Access Compliance Report

Public Rights-of-Way

(Curb Ramps)

Intersection ID: 11933	Main Street: N_TRYON_ST	Cross Street: E_8TH_ST	Location: E
ADA ID: 95F1D444045B	Ramp Type: Perp	Initial Pass/Fail: Fail	Overall Compliance: No
Severity Score: 12.5			
Codes/Mitigation Info/Possible Solution		Field Measurements/Component Compliance

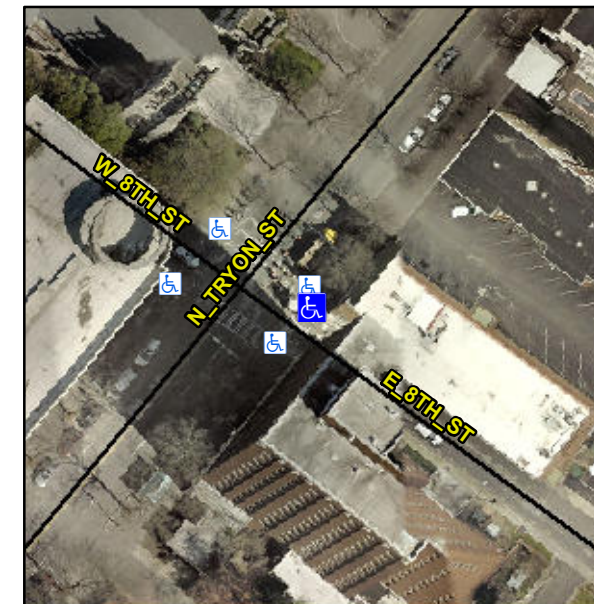
R304.2.2

Remove & Replace Entire Ramp.
